LIMERICK GENERATING STATION
 PROBABILISTIC RISK ASSESSMENT

REVISION 5 PAGE CHANGES

This revision consists of responses to the NRC request for additional information and updates the PRA to September of 1982. All items contained in this section are grouped according to the Chapters and Appendices of the PRA. Revision of existing pages was due to either, the clarification of responses to previously submitted questions or the correction of typographical errors. Responses to the NRC request for additional information dated August 10, 1982 are inserted at the end of each section. The page numbering has not been redone; rather a suffix has been added to the page number for all inserted material.

COOLANT INJECTION AND
ONE MODE OF THE COOLANT
RECIRCULATION

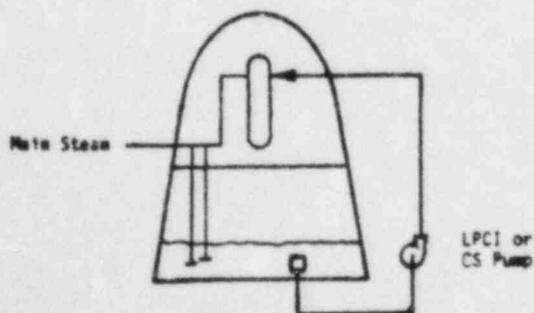
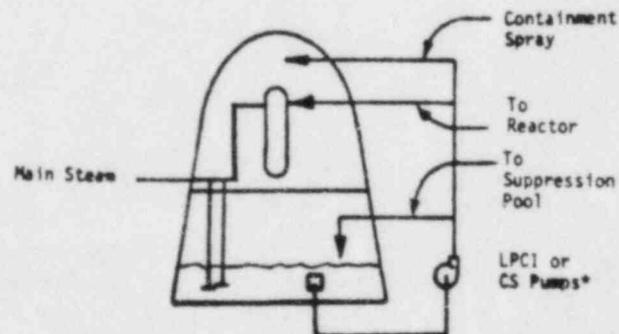
The text indicates (p. 3-43) that the success criteria and calculated probability of long term coolant recirculation and short term coolant injection are similar. Why are the success criteria for long term and short term demands the same? What is the difference in system configuration between coolant injection and coolant recirculation?

Given the long time nature of some of the accident scenarios— in the order of twenty to thirty hours, was failure subsequent to successful system actuation addressed in the Limerick study (failure to run)? If yes, were the degraded environmental conditions under which the systems must operate taken into consideration?

FIGURE 1

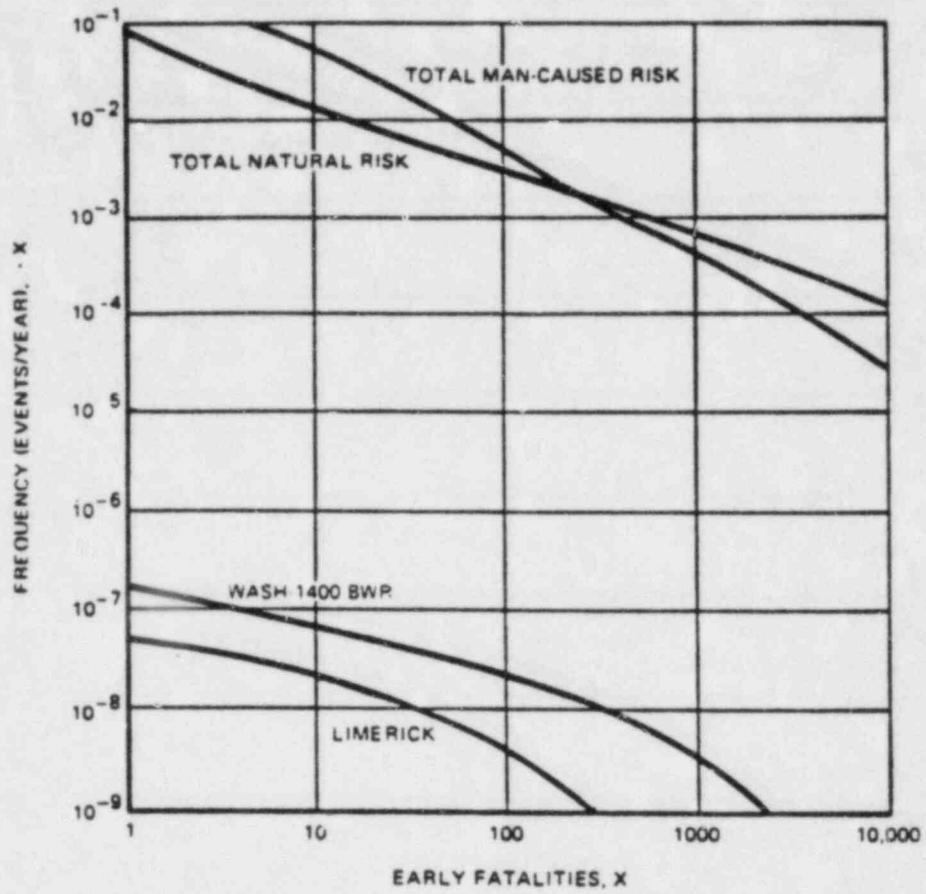
Explain in detail how Figure 4.3 was generated. What exactly was used to compute the risk of Limerick at WASH-1400 composite site with WASH-1400 data methods?

STEP 1: Figure 1 (attached) was constructed. This is Figure 4.4 in Revision 3 to the PRA.

FIGURE 6

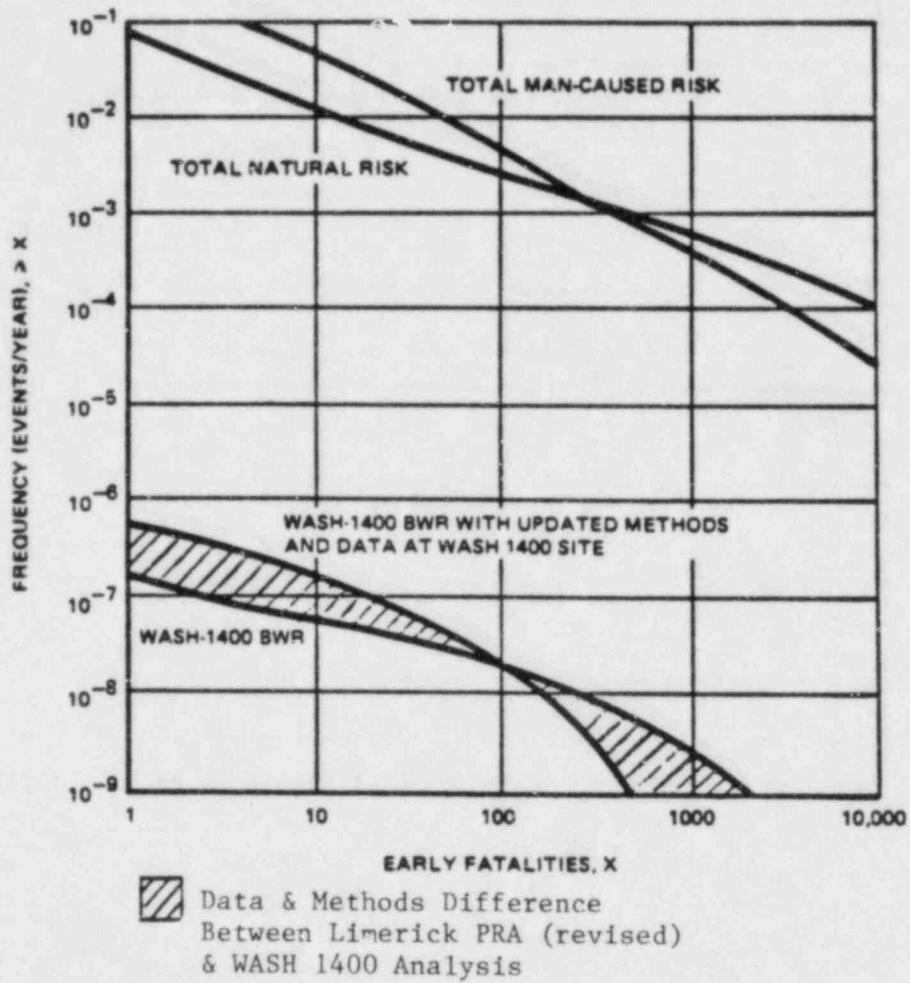
How was Figure 4.2 "WASH-1400 BWR with updated methods and data" obtained?

STEP 6: Figure 6 (attached) was constructed. This is Figure 4.2 in Revision 3 to the PRA.

This figure was constructed only to allow direct comparison to the WASH-1400 CCDF. The curve that is lower on the left is the WASH-1400 CCDF repeated from Figure 1.

The curve that is uppermost on the left represents the WASH-1400 BWR at the WASH-1400 site with the data and methods used in the Limerick analysis. This curve was not generated directly from a CRAC run. It was generated by applying the difference between the two curves of Figure 5 to the WASH-1400 CCDF, by ratio. Points on this curve have the same ratio to the WASH-1400 CCDF as the ratio between the two curves on Figure 5.

The only difference between the two curves is the effect of differences in data and methods. As shown on Figure 5, the methods and data used in the Limerick analysis produce a somewhat higher CCDF at lower consequences and a somewhat lower CCDF at higher consequences.
